HOPE CREEK GENERATING STATION  
DOCKET NO. 50-354  
FSAR COMMITMENT STATUS THROUGH AUGUST 1984

ATTACHMENT I  
HOPE CREEK GENERATING STATION  
FSAR COMMITMENT STATUS THROUGH AUGUST 1984

QUESTION 220.21 (SECTION 3.7.2)

FIGURE ~~210-21-52~~ 210.21-52  
 RESPONSE SPECTRA COMPARISON,  
 INTAKE STRUCTURE AT ELEV. 93'-0".  
 VERTICAL, OBE, 2% DAMPING

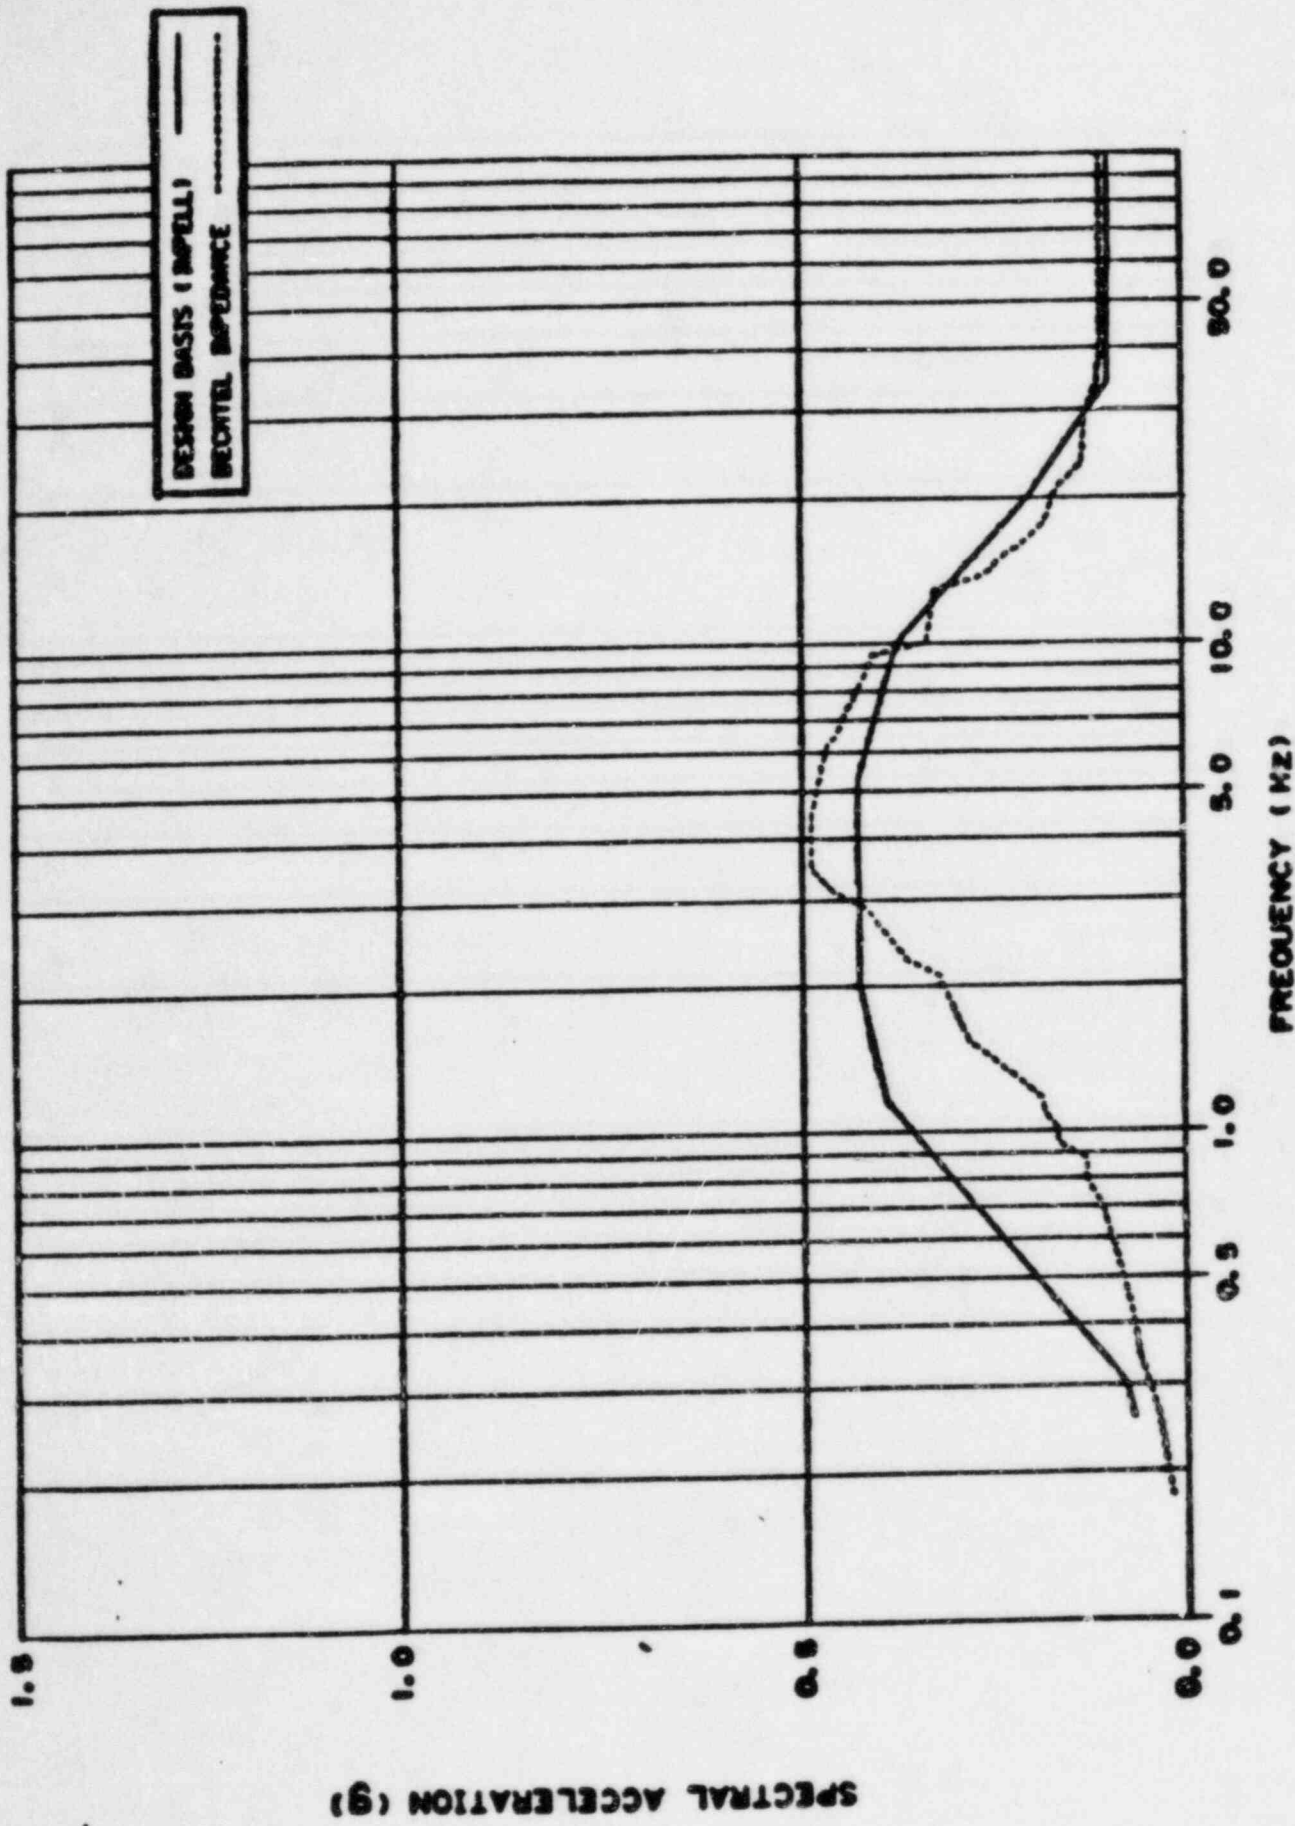
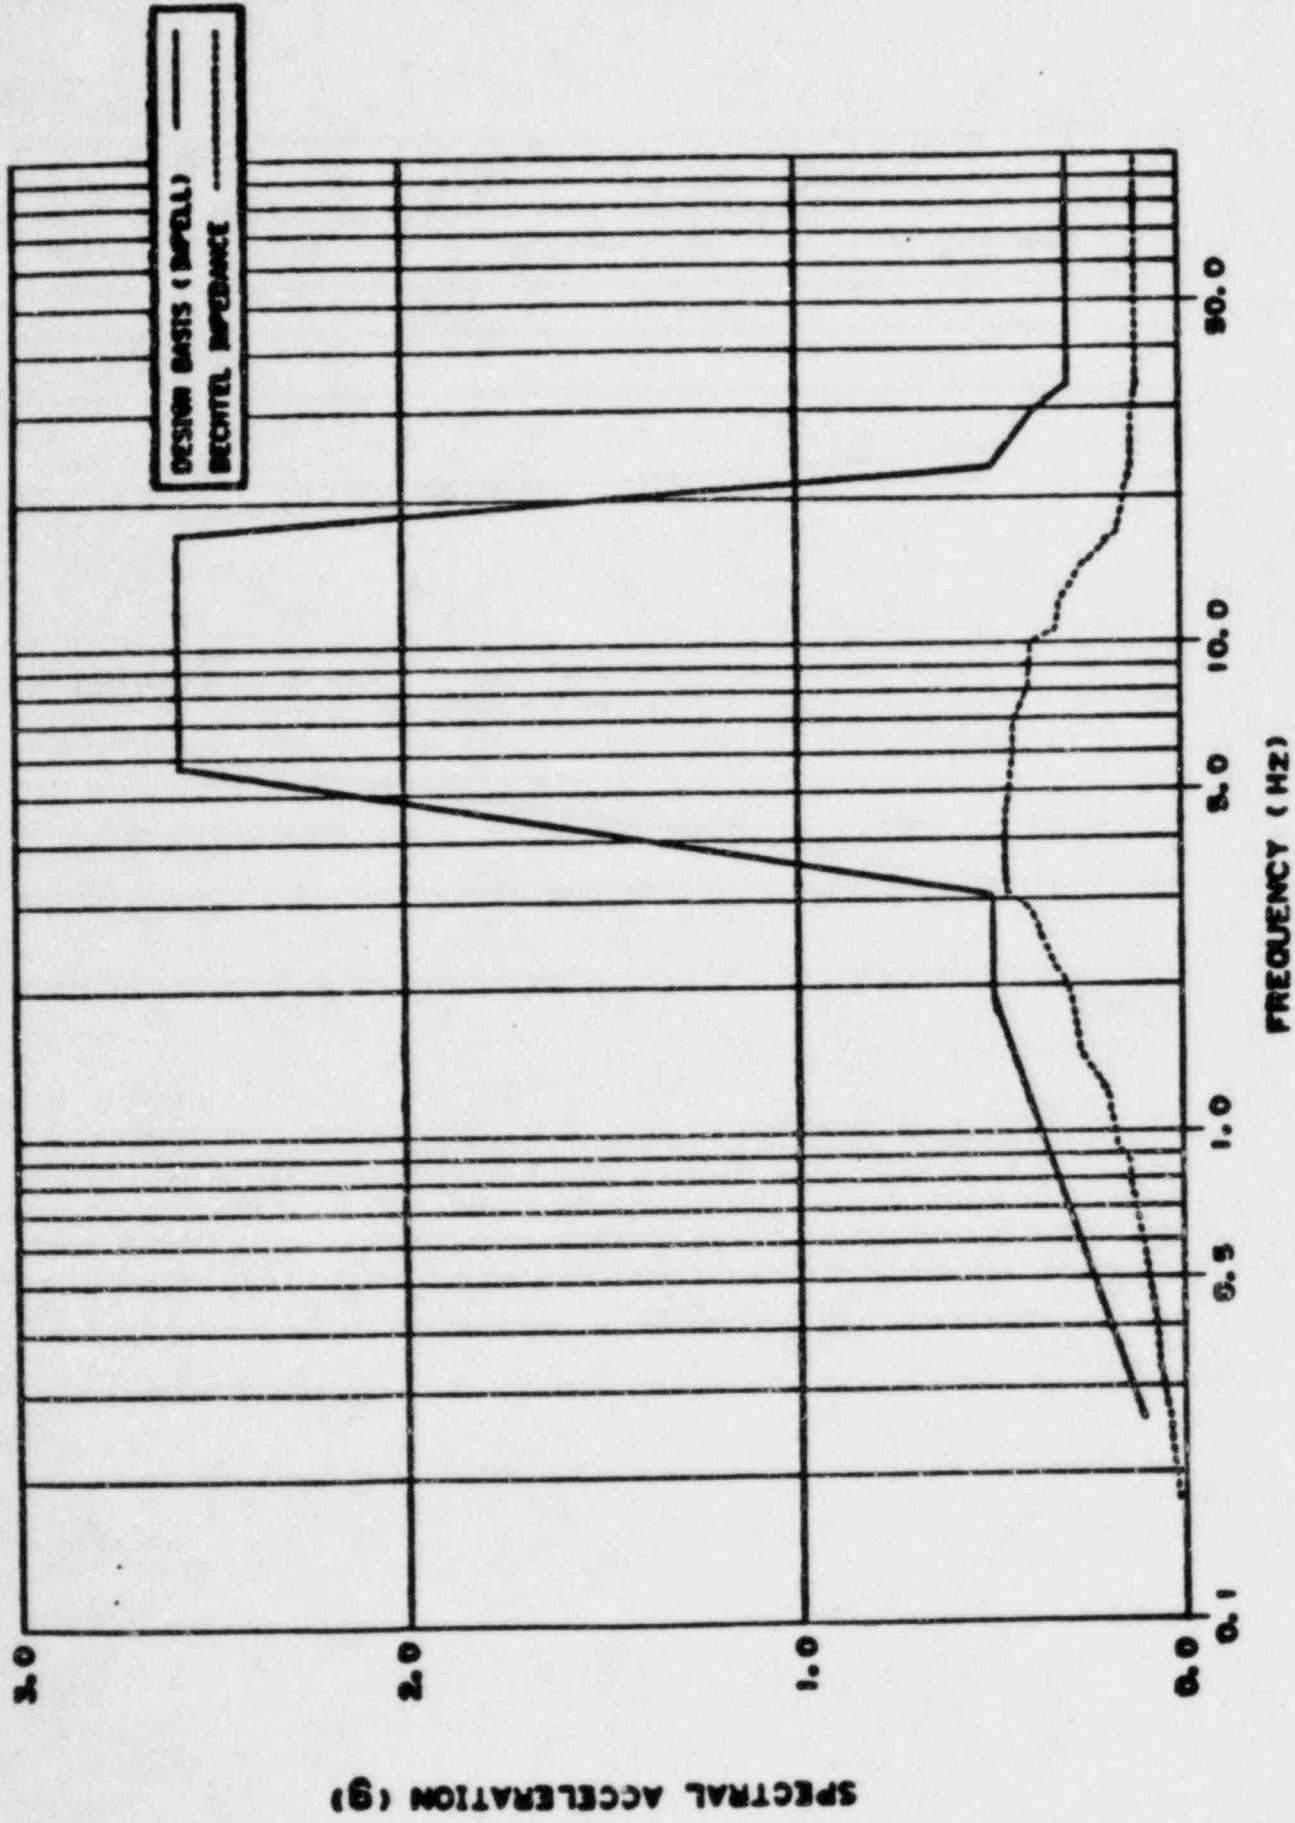
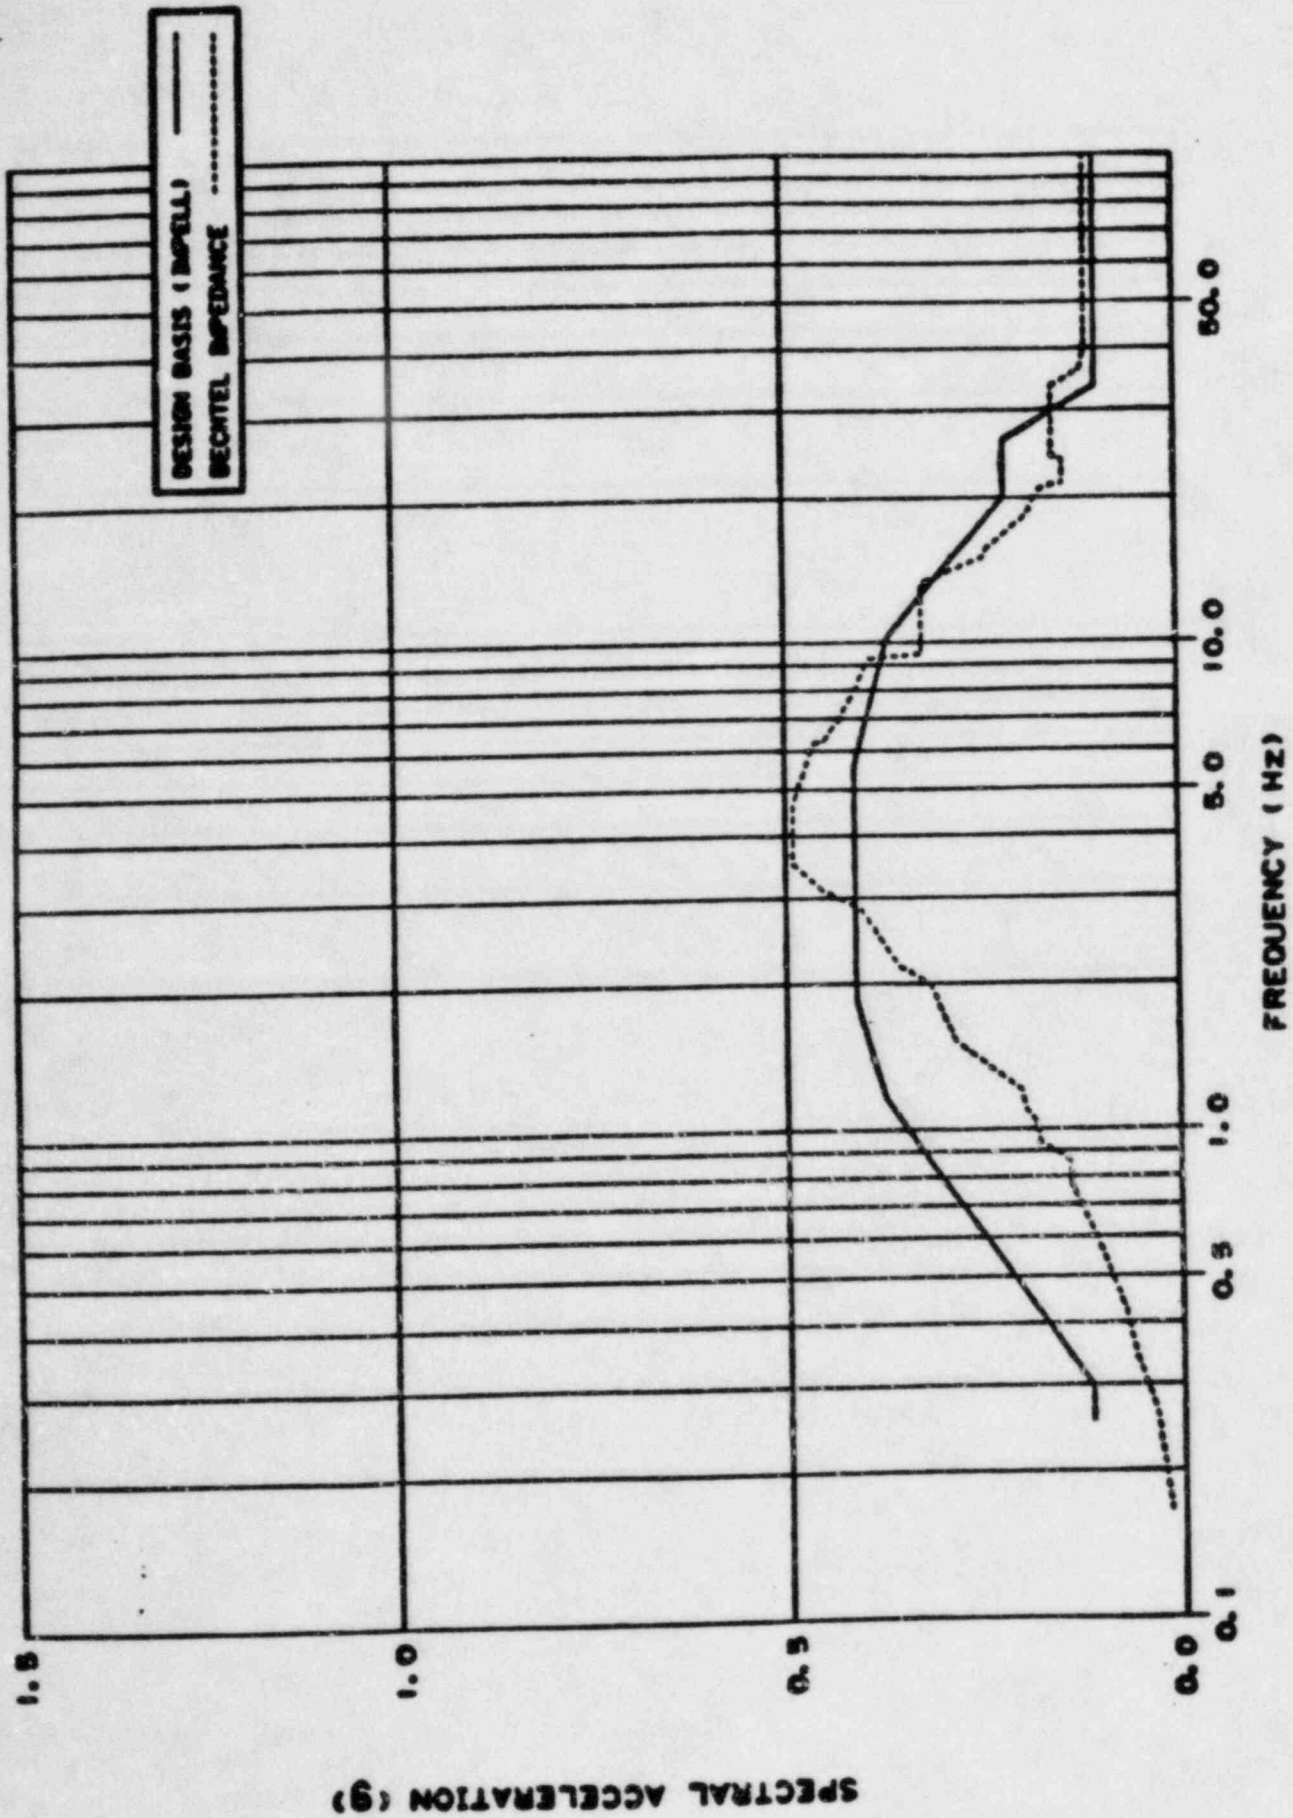
The Hope Creek soil-structure interaction analysis is performed by applying a specified earthquake input motion at the base of the finite-element model. The base level input motion is generated through a deconvolution analysis. The applicable SRP criteria for soil-structure interaction analysis require that both the half-space and finite-element approaches should be considered. (For details refer to SRP 3.7.2-11.4). Public Service should perform necessary analyses to demonstrate conformance to the criteria.

Figures 220.21-1 through 220.21-54 show a comparison of the 2 percent damping response spectra obtained from the design basis finite element and the impedance analyses for the reactor building, auxiliary building and the service water intake structure (SWIS).

¶ For the reactor and auxiliary buildings, the peak spectral accelerations obtained from the impedance analysis are generally lower than those obtained from the design basis analysis. However, the impedance analysis response spectra are not completely enveloped by those obtained from the design basis analysis, especially in the frequency range from 1.0 to 3.5 Hz. Also, there are some local exceedances in the higher frequency range, as shown in Figures 220.21-1 through 220.21-36. ¶ For the SWIS (Figures 220.21-37 through 220.21-54), the impedance analysis response spectra are generally enveloped by those obtained from the design basis analysis at elevation 114.0 feet. For other elevations, the impedance analysis spectral accelerations exceed the design basis spectral accelerations in some frequency ranges. These ranges vary approximately between 1.5 and 10.0 Hz.

forces and moments obtained from the impedance analysis exceeded the design basis values at various locations within these buildings. The auxiliary building seismic shear forces and moments obtained from the impedance analysis are less than the design basis shears and moments.

Since the impedance analysis results are not completely enveloped by the design basis finite element analysis results, sampling studies are conducted to confirm the adequacy of the plant design. These sampling studies include an evaluation of the following items:

In all cases, the items reviewed during these sampling studies can accommodate the loads resulting from the impedance analysis. Therefore, the impedance analysis results have no impact on the plant design.
